Project Name: Holy Family Parish Expansion / Master Plan Submittal  
Project Address: 7045 120<sup>th</sup> Avenue NE  
File No: PRE14-00695  
Parcel: 09205-9018

## **DEVELOPMENT STANDARDS LIST HOLY FAMILY PARISH MASTER PLAN, FILE NO. ZON14-02303**

Permit #: ZON-02303  
Project Name: Holy Family Parish Master Plan  
Project Address: 7045 120th Ave. NE  
Date: January 16, 2015

**Subject:** STATE ENVIRONMENTAL POLICY ACT (SEPA) ENVIRONMENTAL DETERMINATION  
HOLY FAMILY PARISH MASTER PLAN

**Figure 1.** Applicant Proposed Redesign of NE 119<sup>th</sup> Avenue/NE 74<sup>th</sup> Street

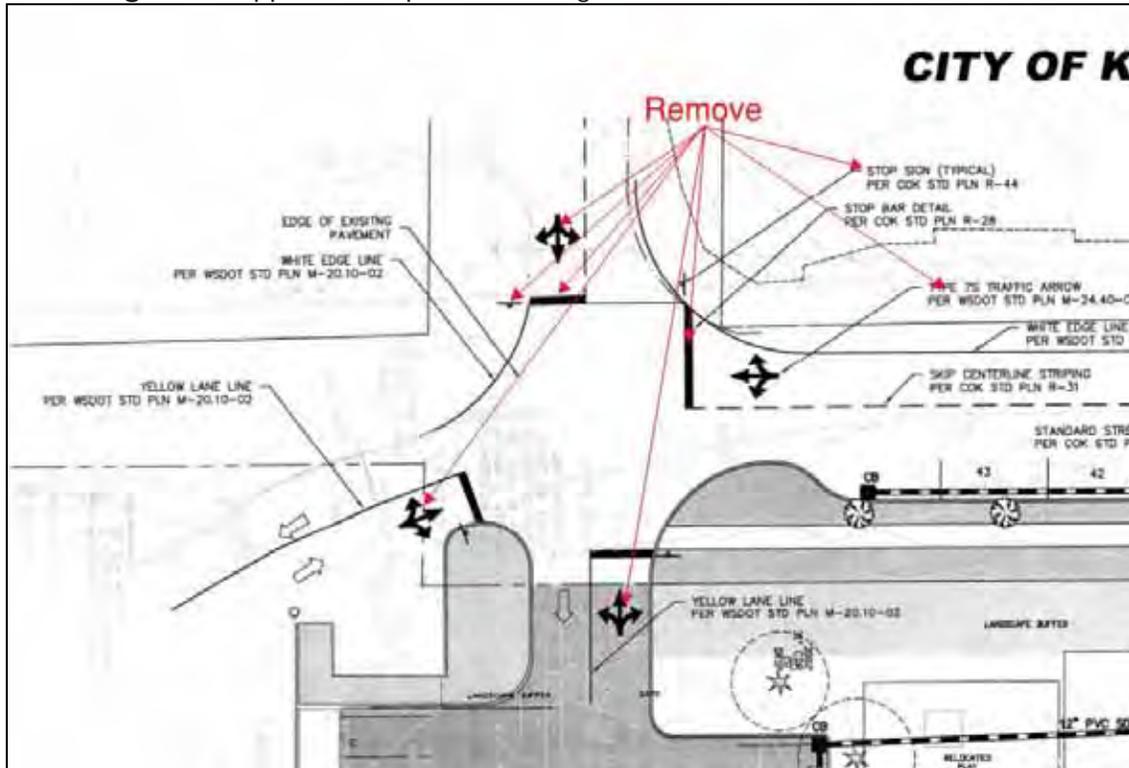
The three-legged intersection of 119<sup>th</sup> Avenue NE/NE 74<sup>th</sup> Street is proposed to become a 4-legged intersection with the proposed additional driveway to the new on-site overflow parking area. Staff agrees with the proposed redesign of the intersection as shown in Figure 1 with the exception of the STOP signs on the west and north leg of the intersection. Based on the forecasted traffic volume and low usage of the project driveway on the weekdays, staff does not believe that the intersection warrants a 4-way STOP control. STOP signs should only be installed for the project's driveway. Drivers from NE 74<sup>th</sup> Street and from 119<sup>th</sup> Avenue NE shall continue to have the right-of-way.

**Note:** In red are staff's recommendations.

1. Pay transportation impact fees as discussed in the Transportation Impact Fee section of this memo.
2. Redesign the intersection of 119<sup>th</sup> Avenue NE/NE 74<sup>th</sup> Street as shown in Figure 1 of this memo. As shown on the figure, remove the STOP signs and STOP bars on 119<sup>th</sup> Avenue NE and NE 74<sup>th</sup> Street. Remove arrow pavement markings for all approaches. For improved traffic control at the intersection, install curbs and centerline striping to define the intersection and roadway alignment and install stop signs at the project driveways.
